STAFF REPORT ACTION REQUIRED

84 Crescent Road, Alteration of a Structure in the South Rosedale Heritage Conservation District

Date:	September 29, 2009
То:	Toronto Preservation Board Toronto and East York Community Council
From:	Director, Policy and Research, City Planning Division
Wards:	Toronto Centre – Rosedale – Ward 27
Reference Number:

ATTACHMENT NO. 3

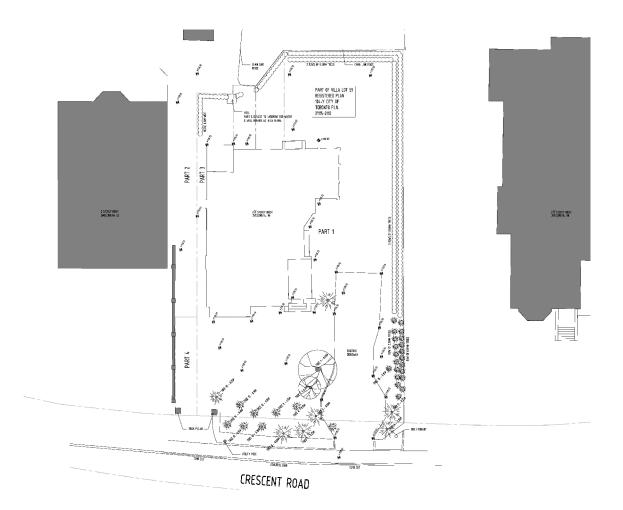
The existing building (Attachment Nos. 2 and 3) is categorized as an "A" in the SRHCD Plan. Buildings categorized as "A" are considered to be individually outstanding, to have national or provincial significance and contribute to the heritage character of the District. Of note, the SRHCD study indicates that 37 properties have an "A" rating; this is out of a 724 identified potential heritage buildings and approximately 1080 total buildings in South Rosedale.

It is staff's opinion that the proposed alteration does not comply with the Section 5.3.2. guideline, "Reasonable effort should be taken to repair rather than replace significant architectural elements" as the sun room:

- is a heritage attribute of this 'A' rated house;
- is an architectural feature visible from the street;
- contributes to the heritage character of the neighbourhood;
- is in good condition.

As such, it has not been demonstrated to staff that 'reasonable' effort has been taken to maintain this heritage attribute as viewed from the street as part of the proposed interior reorganization, energy efficiency alterations and increased second floor height.

As an alterative, staff had proposed to the applicant the following conservation strategy which would maintain this heritage attribute as viewed from the street and allow for the intended alterations:

- limit removal of this attribute to the exterior walls not visible from the street;
- incorporate energy efficiency upgrades sensitively into the existing building envelope, ie: new insulation of walls and roof from interior, improved heating and cooling as part of the interior renovations, window improvements as appropriate (re-glazing, new storm windows or replacement wood windows to match appearance of existing), etc.; and
- alter the existing roof line from a pitched roof to a flat roof to accommodate an increased height.

EXISTING ELEVATIONS: 84 CRESCENT RD

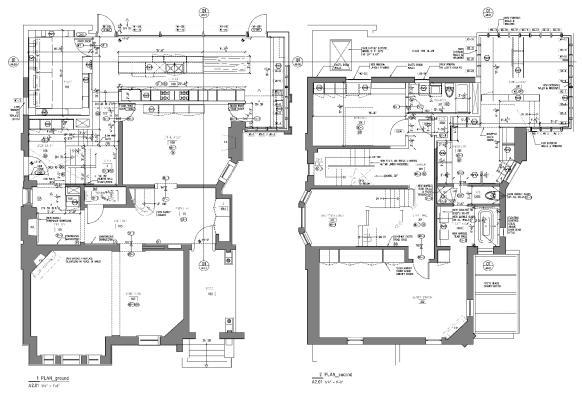
The applicant is proposing to remove the existing 2 storey sun room excluding the part of the existing sandstone and brick foundation wall and replace it with a new 2 storey sun room addition (Attachments Nos. 5, 6 and 7). This house was designed by the Toronto architecture firm Langley & Langley and constructed in 1899. The firm of Langley & Langley was led by Henry Langley and his son Charles Langley; they partnered from 1892 until Henry's death in 1907. Henry was a pupil of William Hay and Charles was the first graduate of the University of Toronto's School of Architecture in 1892. They worked on many of the City's finest properties including St. Michael's Cathedral, the Government House and the Necropolis. Based on visual investigation, the sun room has been determined to be an addition to the original house likely constructed in the 1920s or 30s.

The proposed replacement sun room will be a 2 storey addition which respects the existing building footprint. The proposed height is 21'- 4 5/8" to the top of the roof parapet; this is to the underside of the existing soffit. The proposed addition is in the contemporary architectural style. The cladding will be dark zinc or wood painted panels with a dark zinc or pre-finished aluminium flashing and aluminium windows. The existing brick base and sandstone sill is to be retained on the south elevation and in part on the east elevation (Attachment No. 5, 6 and 7).
